SIDE
2

HR SIDE

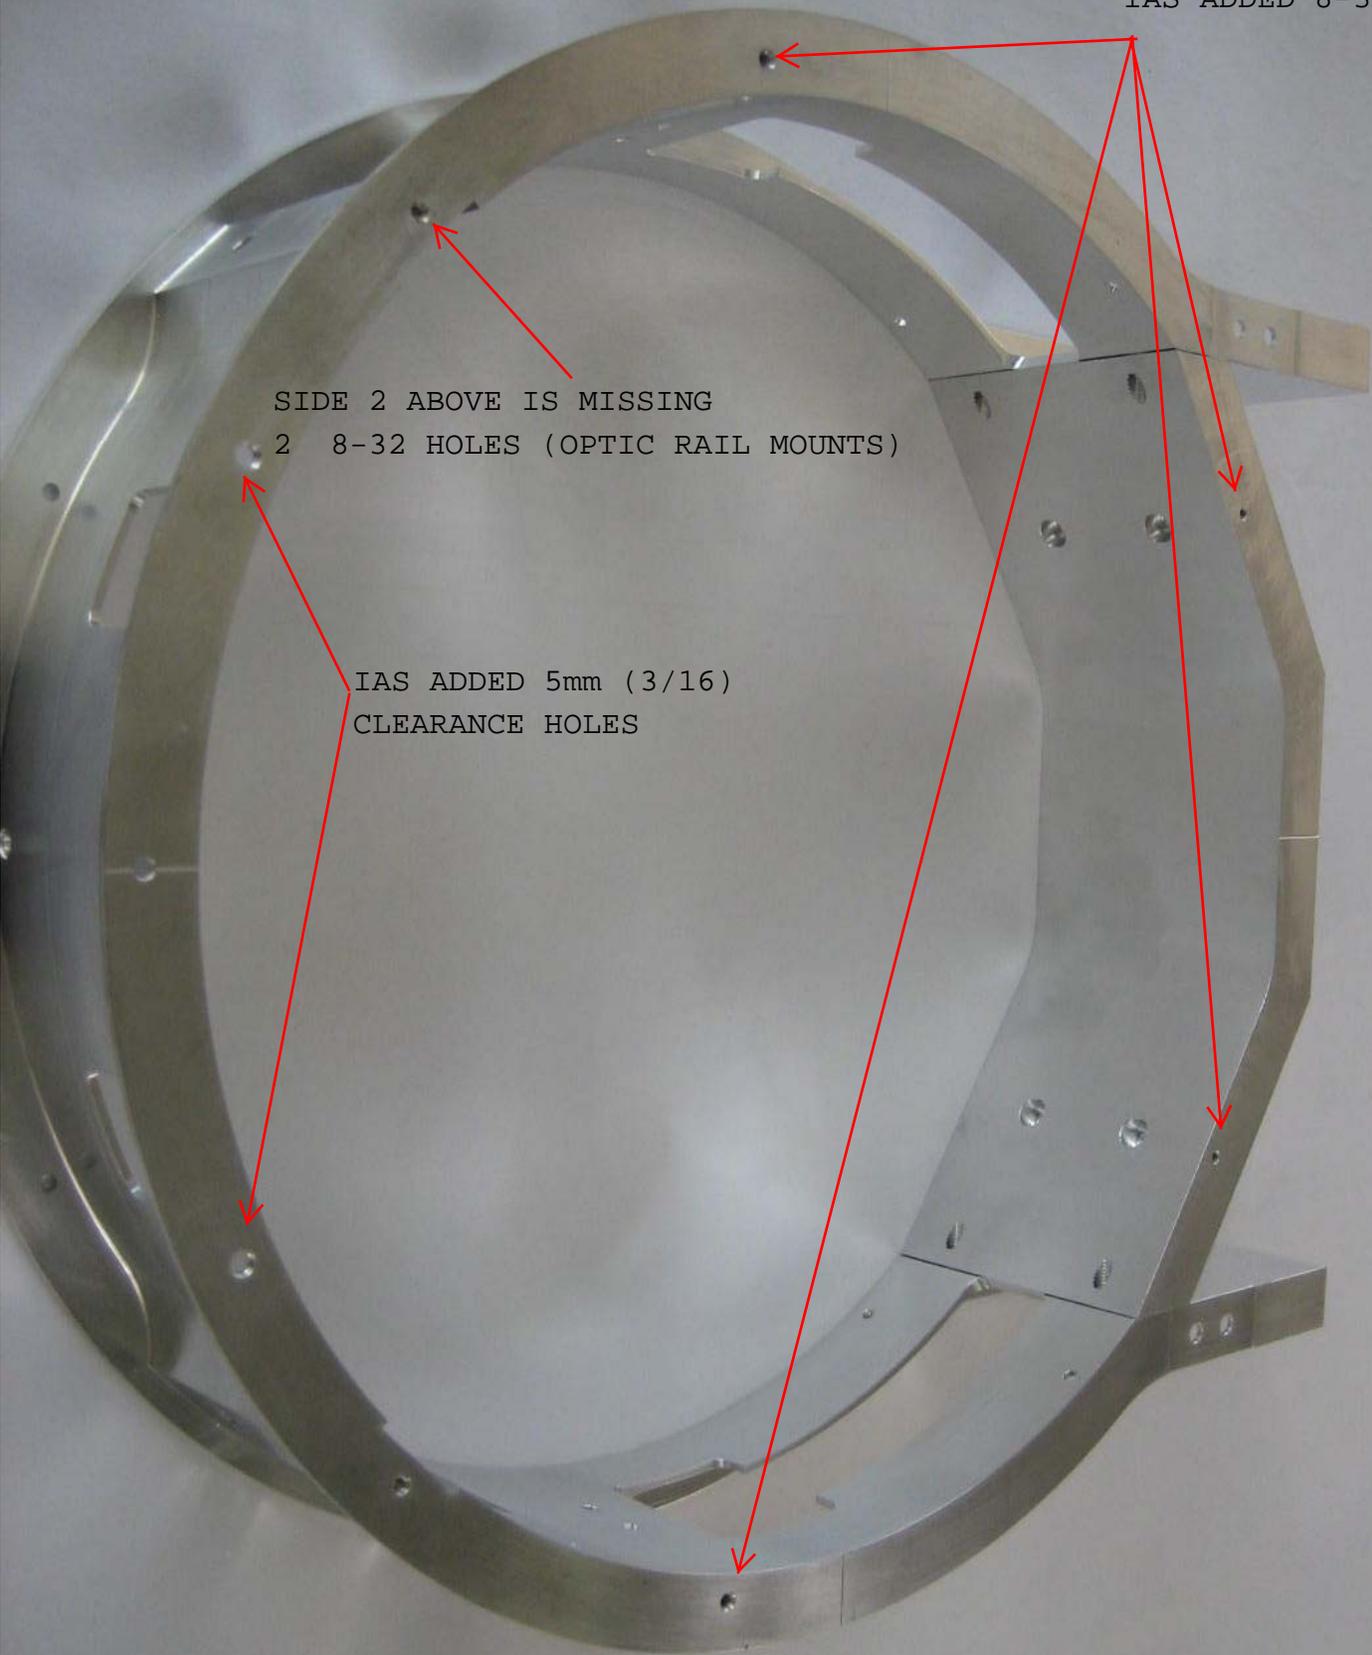
SIDE 2 ABOVE IS MISSING
2 8-32 HOLES (OPTIC RAIL MOUNTS)

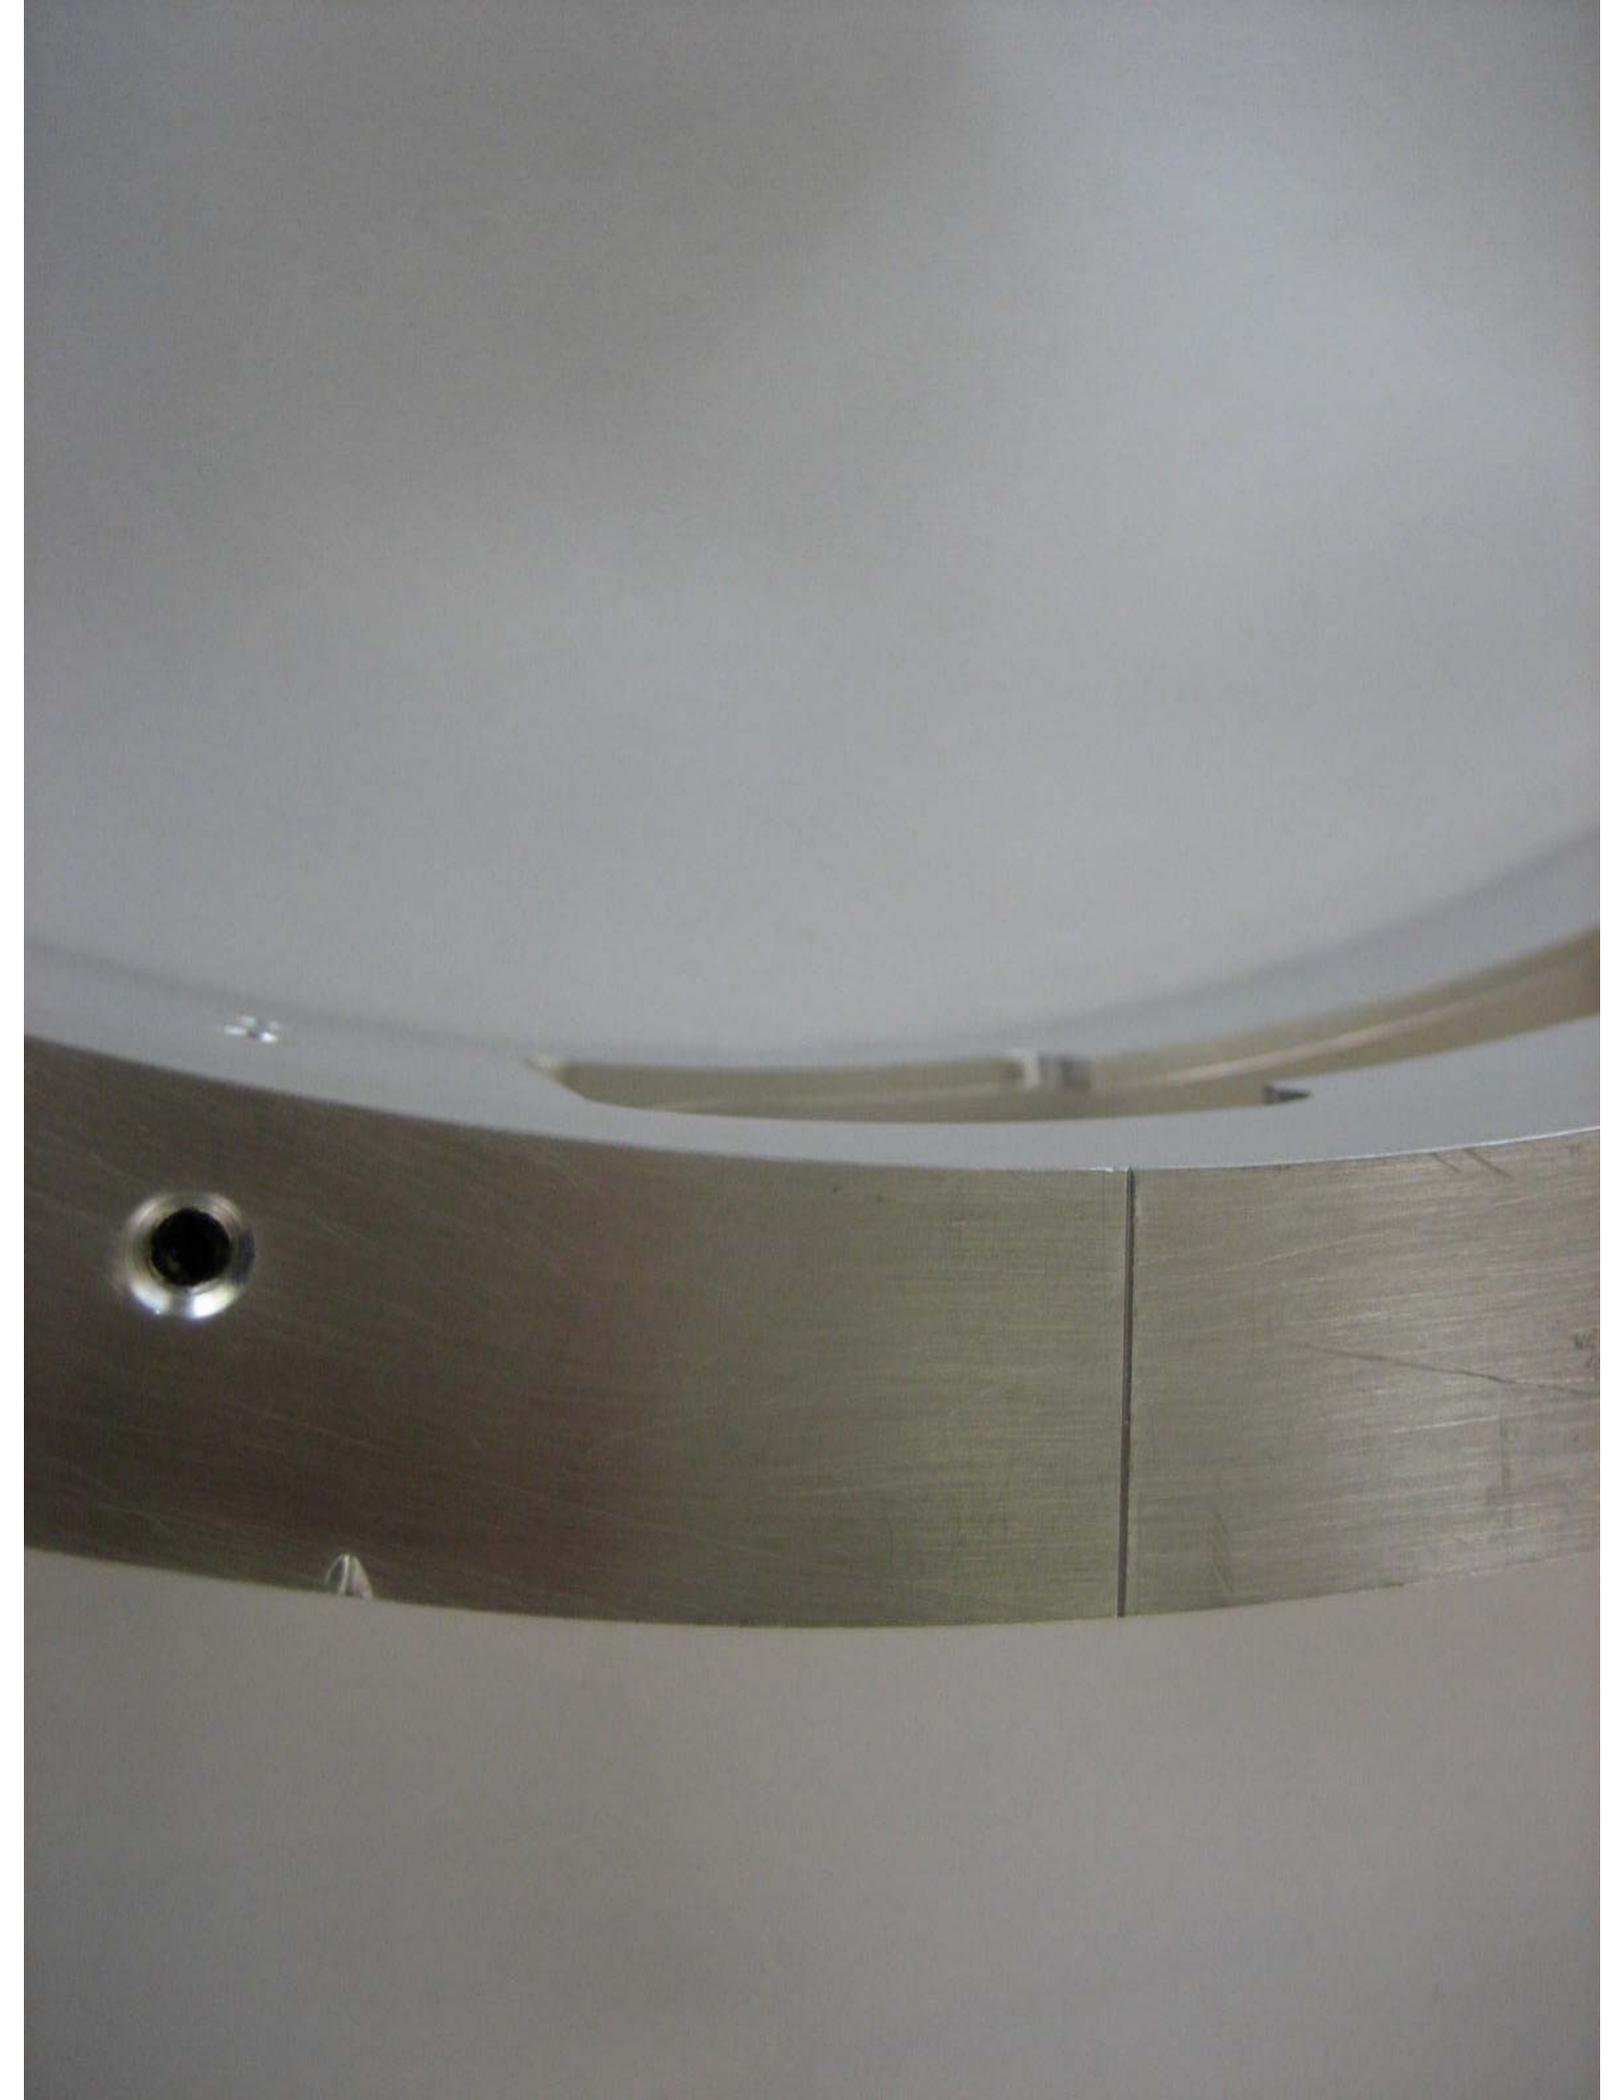
IAS ADDED 8-32 HOLES

IAS ADDED 5mm (3/16)
CLEARANCE HOLES

ENGRAVED LINE AT BOTTOM OR HOLE LOCATION OFF
ON S/N 14
